<b>JRPP No.</b>	<b>2009SYE018</b>
<b>DA No.</b>	<b>DA200900410</b>
<b>Proposed Development</b>	<b>52-60 Enmore Road, Newtown - Newtown RSL redevelopment</b>
<b>Applicant:</b>	<b>Gordon King</b>
<b>Report By:</b>	<b>Ali Hammoud (Marrickville Council)</b>

## **Assessment Report and Recommendation**

Image 13: Roof Plan

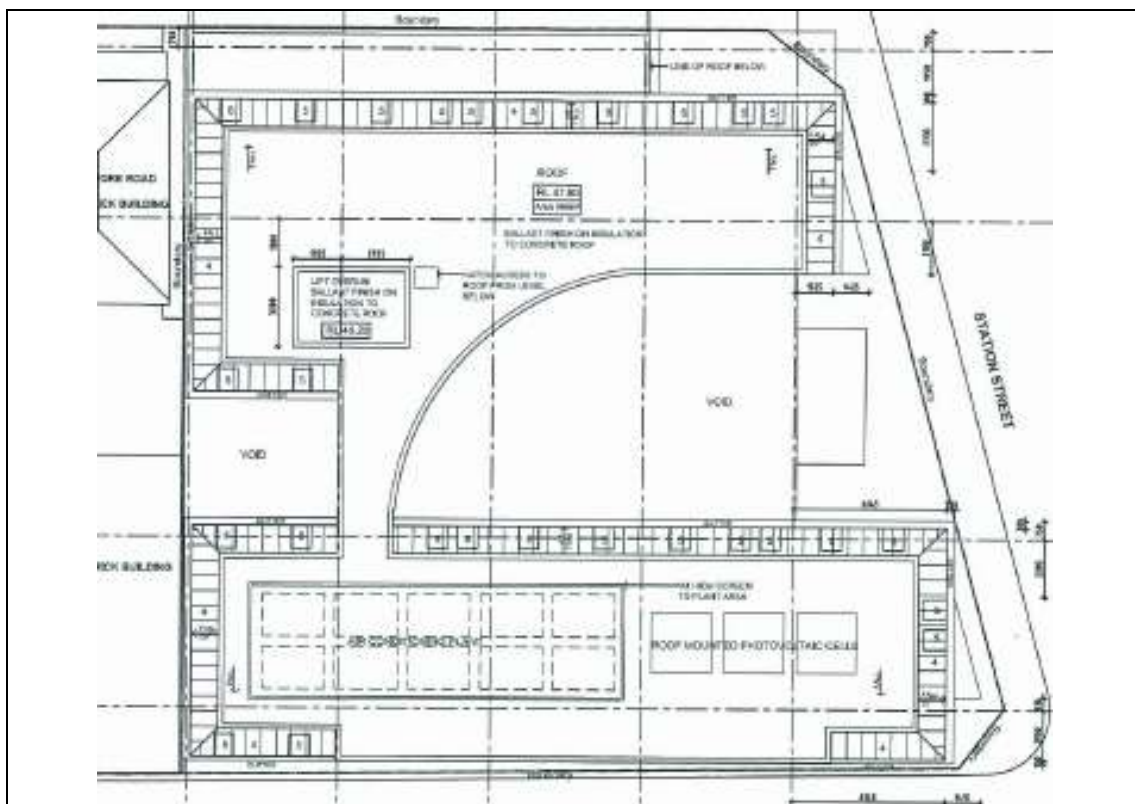
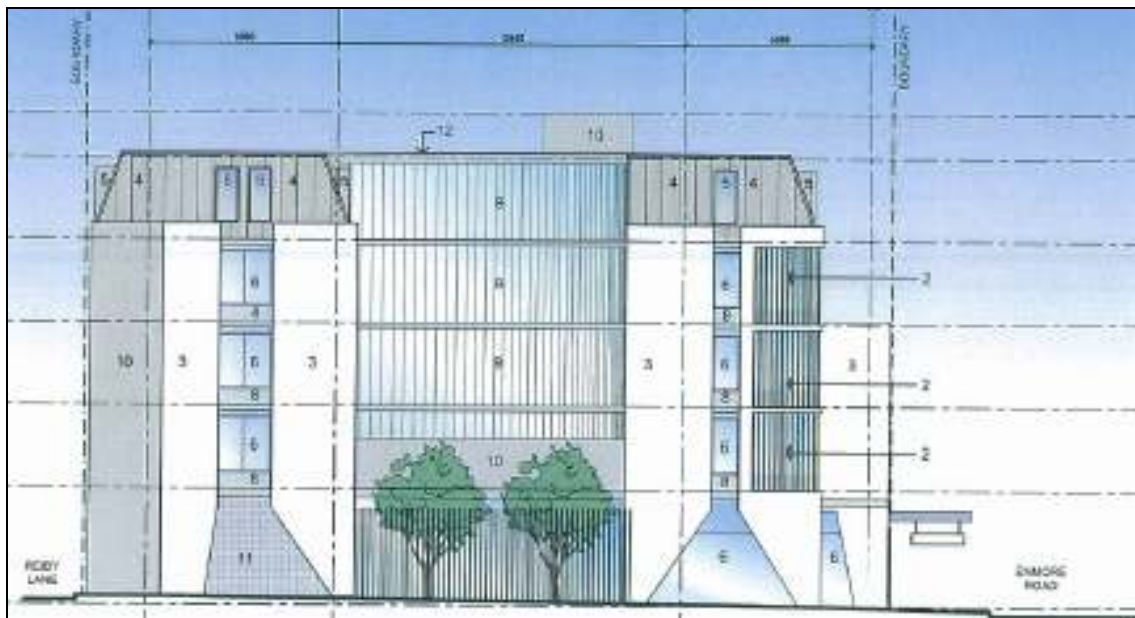
5. The proposed roof form is inconsistent with the roof forms prevalent along this section of Enmore Road and includes a number of dormer windows within the roof along the Enmore Road and Station Street frontages. Consequently, the proposed roof form is inconsistent with the roof and parapet objectives and controls contained in Marrickville Development Control Plan No. 34 - King Street and Enmore Road Heritage and Urban Design.

*Image 19: Existing and Proposed Streetscape Elevations*

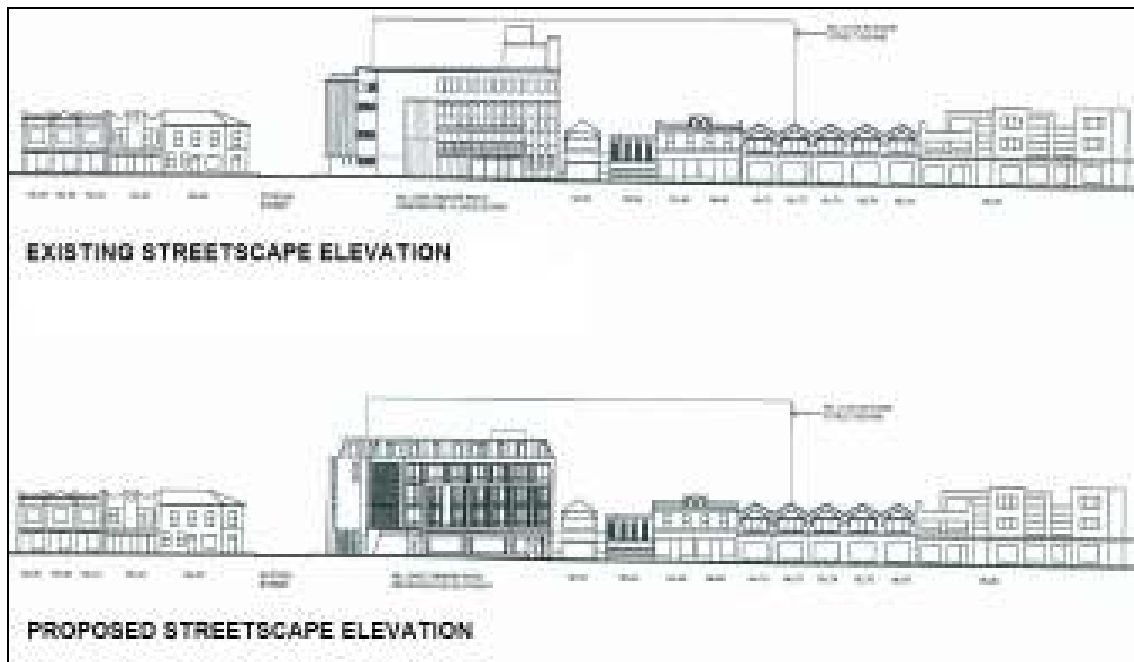
The plan clearly shows additional bulk on the top of the building which results in the proposed building further exacerbating the disproportionate height, bulk and scale relationship of the existing building with the streetscape along this section of Enmore Road.

As has been mentioned throughout this report, the proposed building height and built form are considered inappropriate in the streetscape. For the reasons outlined above, the proposed development fails to satisfy FSR objective O2 of Marrickville Development Control Plan No. 28 - Business Centres (DCP 28). The proposed development is not within the acceptable bulk and scale parameters for Enmore Road as prescribed by DCP 34 and consequently, the proposed development fails to satisfy the density objective contained in DCP 34. Therefore, the contention by the application that *"The proposal is consistent with the objectives for the floor space ratio standard as expressed in Development Control Plan No. 28 and Development Control Plan No. 34, despite it not strictly complying with the numerical value of that standard contained in Clause 33 (1) of Marrickville Local Environmental Plan 2001"* is not supported.

*Image 20: Existing and Proposed Elevation Shadow Diagram for 22 June*

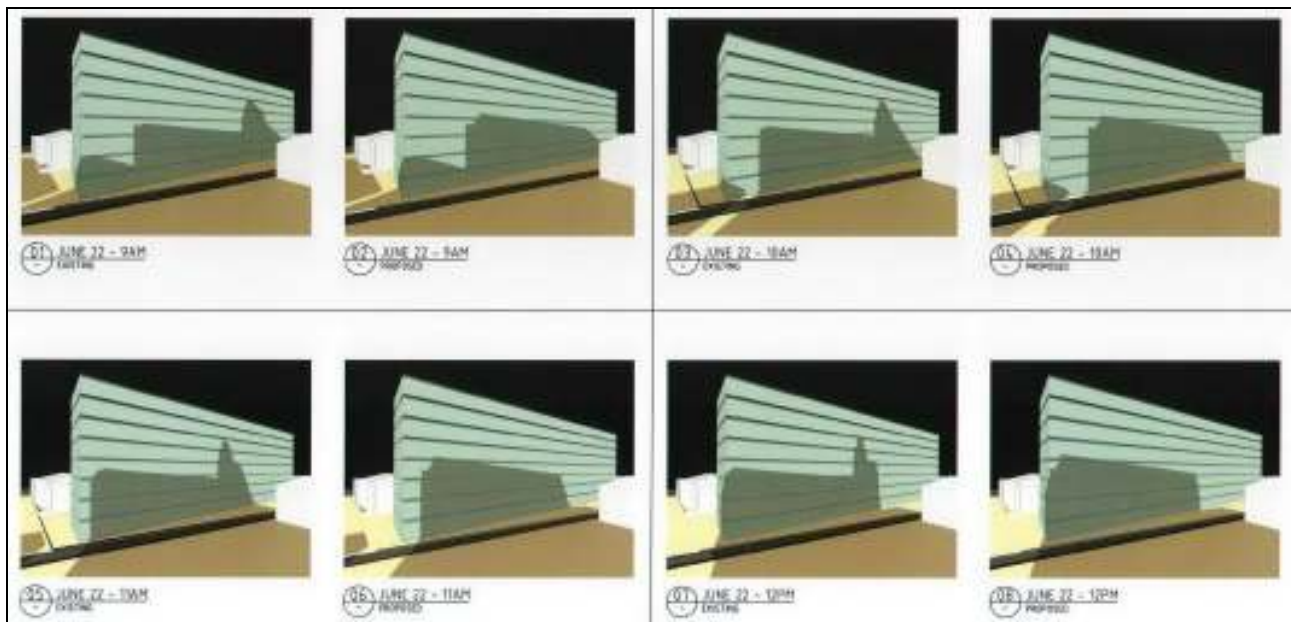
The diagram illustrates that there would be a slight reduction in the overshadowing caused onto the upper levels of the adjoining building but also clearly illustrates that the proposed building would cause greater levels of additional overshadowing onto the residential flat building to the south at mid winter. The extent of additional overshadowing onto that building exceeds the reductions achieved to the upper half of the building with up to one additional level of the building being overshadowed.

*Image 21: Plan Showing Delivery Vehicle Access using Loop*

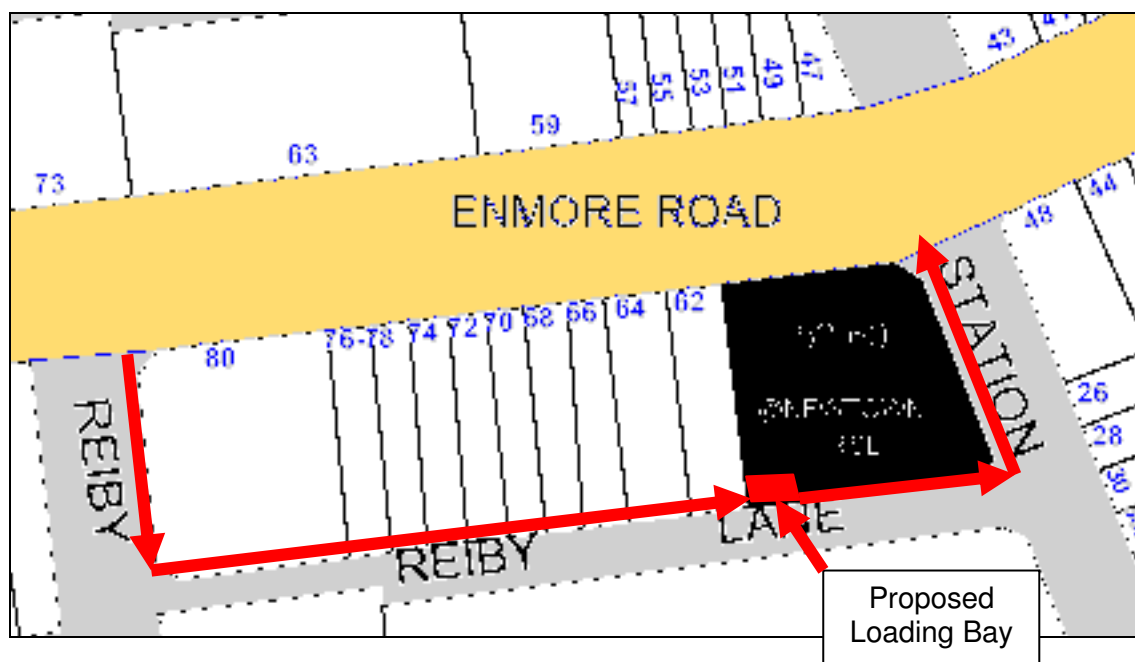
Although street level is the preferred option for providing a loading bay, some of the other elements of the proposed building are considered to hinder the ability for delivery vehicles to practically use the space without having to utilise parts of the adjacent laneway. This includes the placement of bollards in front of the fire door located within the loading space area, which in effect creates an obstacle for delivery vehicles accessing the loading space. Although not detrimental to the overall development, this is an issue which remains unresolved with the proposal.
